Lubrication Maintenance Addendum

**Marquis
Santiam**

The following information supersedes the information published in the 2004 Marquis® Owner's Manual, page 419, section 10 and the 2004 Santiam® Owner's Manual, page 393, section 10. Please utilize the information provided henceforth.

ATG04264

Rear Drum Brake -

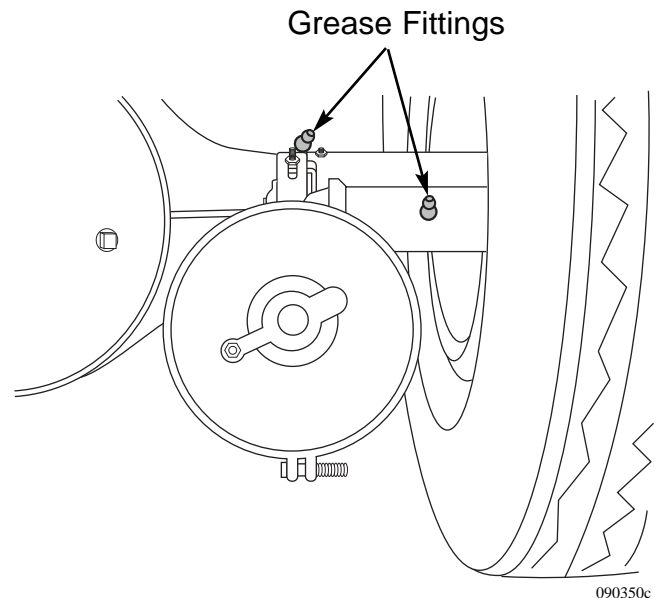
The information on page 419 of the Marquis® manual and page 393 of the Santiam® manual should be updated. The updated information (in bold) reflects the following changes:

The slack adjuster and camshaft need to be lubed periodically to ensure proper brake operation. Lubricate every 10,000 miles or **every six months**.

Lubricate until new grease appears at exit points.

Use NCCI #2 Lithium Soap base grease.

Rear Drum Brake -

Lubricate until new grease appears at exit points.

Use **NLGI #2** Lithium Soap base grease.
